**FINDINGS AND RECOMMENDATION
OFFICE OF PLANNING AND ZONING
ANNE ARUNDEL COUNTY, MARYLAND**

CASE NUMBER: 2025-0009-V

The applicant is requesting a variance to allow an identification sign on an entry facade of a mall that exceeds 10% of the area of the facade and projects above the roof on property located at 6711 Ritchie Highway in Glen Burnie.

PROPOSED

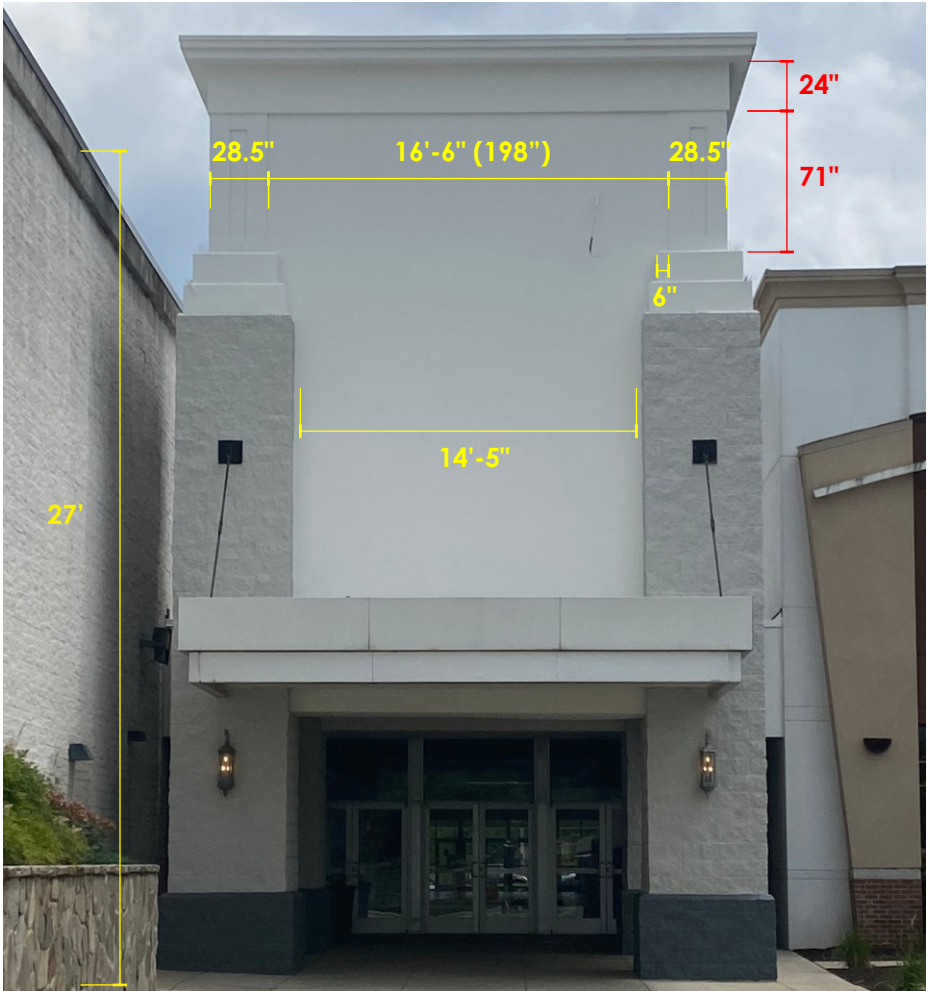
In this particular case, the shopping center has been reconfigured, the facade renovated, and Ollie's will be utilizing the old mall entrance as the entrance to their store. Therefore, identification signage at this entrance would be beneficial, and some relief may be warranted. However, the proposed sign is nearly 25% of the area of the facade, and is located above the rooflines of the structure on either side. It appears that visibility and wayfinding would still be

accomplished by lowering the location of the sign and reducing the area to fit between the decorative grey pillars (noted with a red box in the screenshot below).

This lower area would be in line with the approvable locations of other tenant identification signage and would provide a cohesive look to the newly renovated facades.

Because an alternative exists, the requested variances are not considered the minimum necessary to afford relief and this Office cannot support the variance as proposed.

Based upon the standards set forth in § 18-16-305 of the Code under which a variance may be granted, as proposed, this Office recommends **denial** of a zoning variance to § 18-3-303(b)(4) to allow a sign that projects above the roof of a structure; and **denial** of a zoning variance to § 18-3-308(b)(4) to allow a sign which exceeds the allowable 10% of the area of the facade.
